Wisconsin Department of Transportation

Proposal #13: 2126-00-70
W McKinley Avenue
8TH Street to 3RD Street
Local Street
Milwaukee County

This is Addendum No. 01, which provides for the following:

ADDENDUM NO. 01

Addendum No. 01
 ID 2126-00-70
 Revised Sheet 4
 January 27, 2016

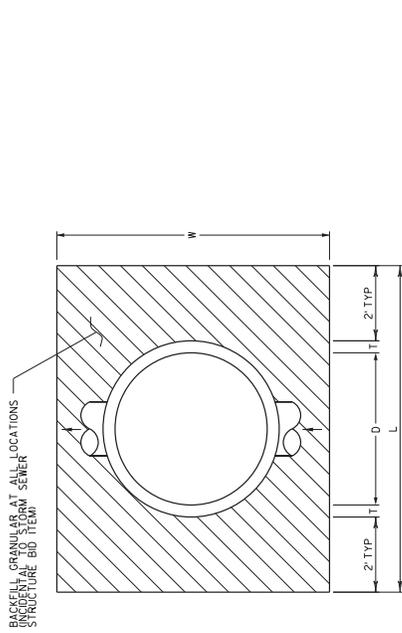
Revised Plan Sheets	
Plan Sheet	Plan Sheet Title (brief description of changes to sheet)
4	Project Overview (Updated to show construction staging and Archaeological site)
85	Traffic Control Stage 1A (Added traffic control items)
86	Traffic Control Stage 1A (Added traffic control items)
87	Traffic Control Stage 1B (Added traffic control items)
88	Traffic Control Stage 1B (Added traffic control items)
89	Traffic Control Stage 1C (Added traffic control items)
90	Traffic Control Stage 1C (Added traffic control items)
91	Traffic Control Stage 2 (Added traffic control items)
92	Traffic Control Stage 2 (Added traffic control items)
93	Traffic Control Stage 3 (Added traffic control items)

Addendum No. 01
 ID 2126-00-70
 Added Sheet 24A
 January 27, 2016

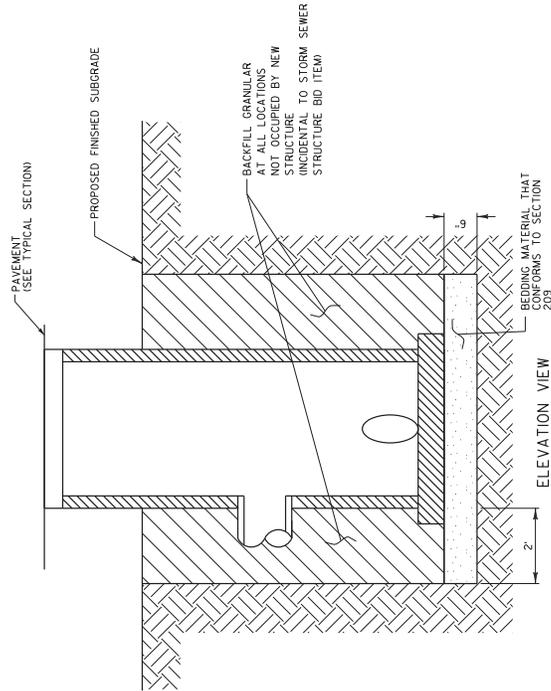
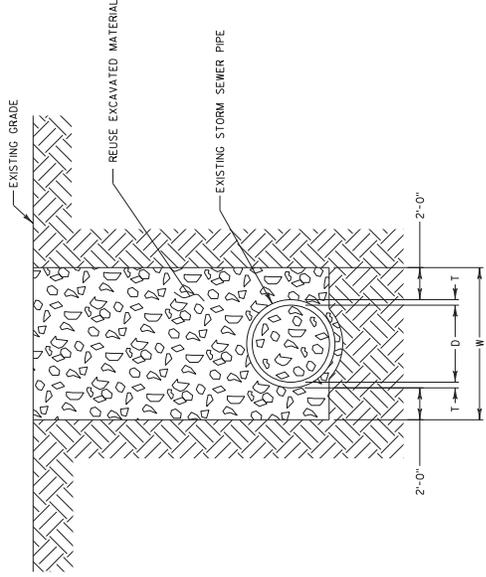
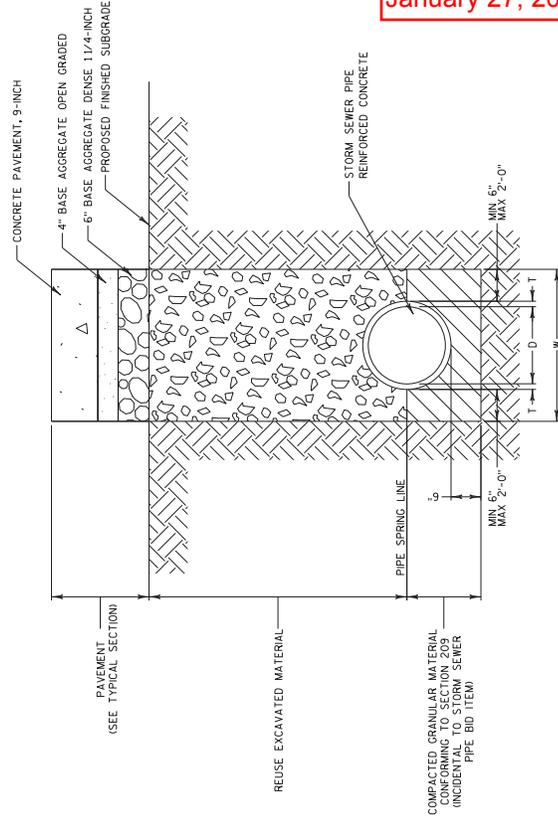
Added Plan Sheets	
Plan Sheet	Plan Sheet Title (brief description of why sheet was added)
24A	Construction Details (Added Backfill Details)
24B	Construction Details (Added Backfill Table – Estimated Quantity for Information Only)
24C	Construction Details (Added Backfill Table– Estimated Quantity for Information Only)
69A	Pavement Marking Removals (Added pavement marking removal for traffic control needs)
72A	Pavement Marking (Added pavement marking to replace removed marking)
176A	Standard Sign M4-9B L&R
182 A	Standard Sign R9-11A

BACKFILL GRANULAR DETAIL - PROPOSED STORM SEWER STRUCTURES

BACKFILL DETAIL - EXISTING STORM SEWER TRENCH AND MANHOLES

BACKFILL DETAIL - PROPOSED STORM SEWER TRENCH
